MOUNTING THE PHENOLIC ROUTER TABLETOP TO THE ROCK-STEADY FOLDING STEEL STAND

BOTTOM VIEW

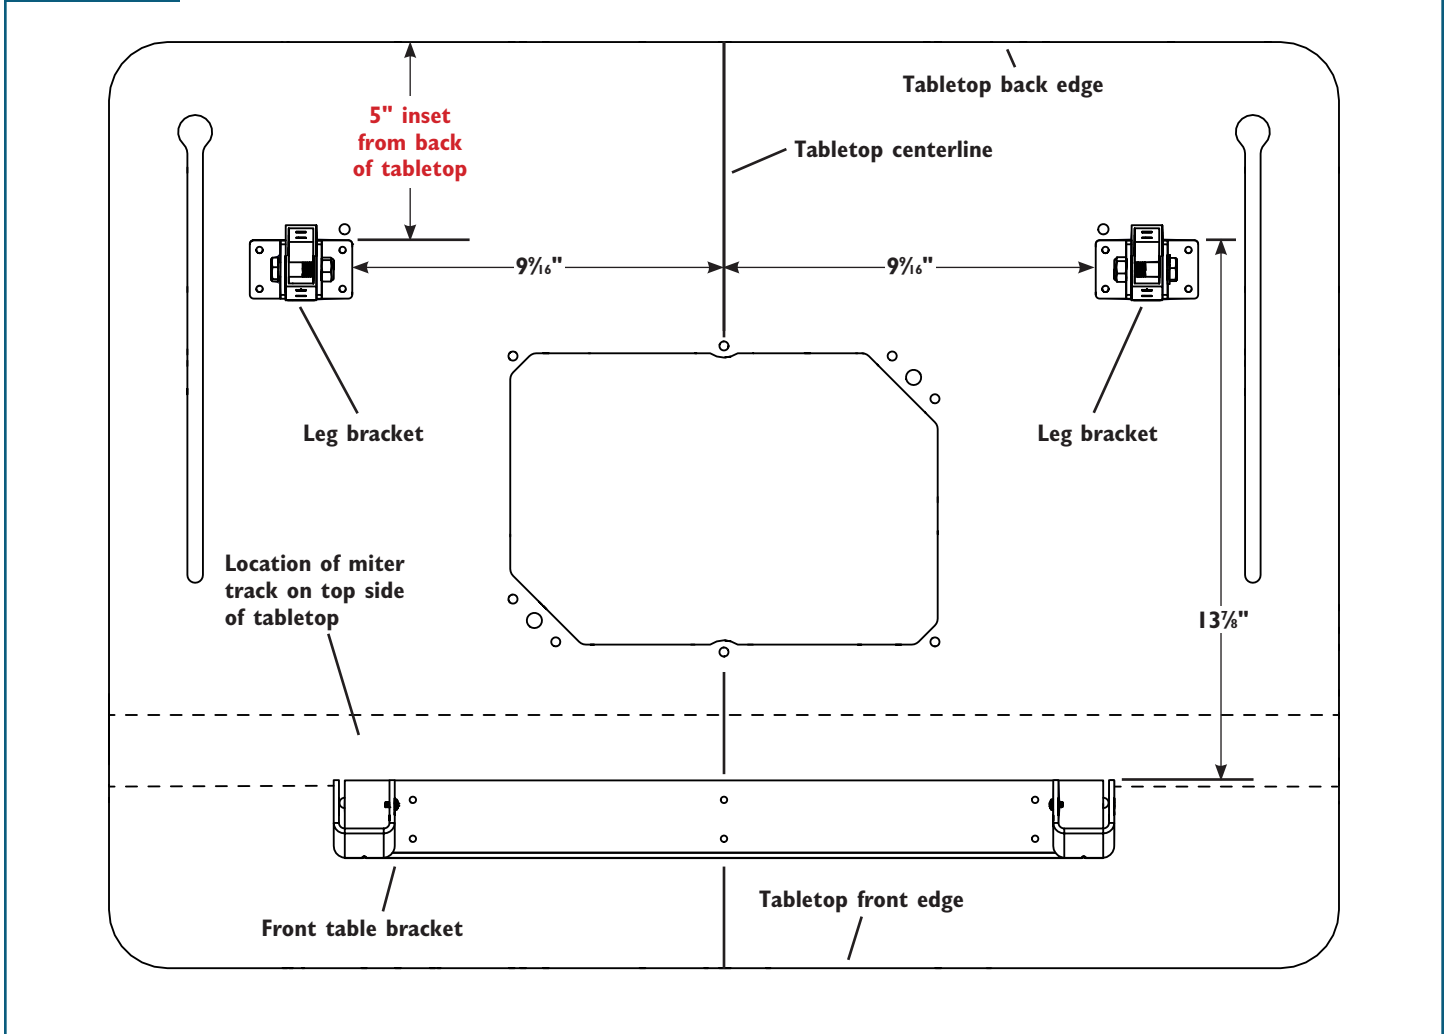
Because the four predrilled holes for mounting the Phenolic Router Tabletop to a stand don't work for the Rock-Steady Folding Steel Stand, the mounting process requires a couple of adjustments. **The steps in the instructions should still be followed, but with these substitutions:**

- **The inset from the back of the tabletop to the leg brackets must be increased to 5".** This is necessary to position the front table bracket in front of the miter track so the mounting screws won't hit the track.
- The #8 x 3/4" mounting screws included with the Rock-Steady Stand are not strong enough for use with the Phenolic Router Tabletop. They are prone to breaking. **Instead, we are recommending the use of #8 x 5/8" self-drilling screws (see image at right) driven into 1/8" diameter pilot holes.** The Rock-Steady stand leg brackets and front table bracket should still be used to mark the locations of the pilot holes.

Recommended fasteners: #8 x 5/8" self-drilling screws in 1/8" dia. pilot holes
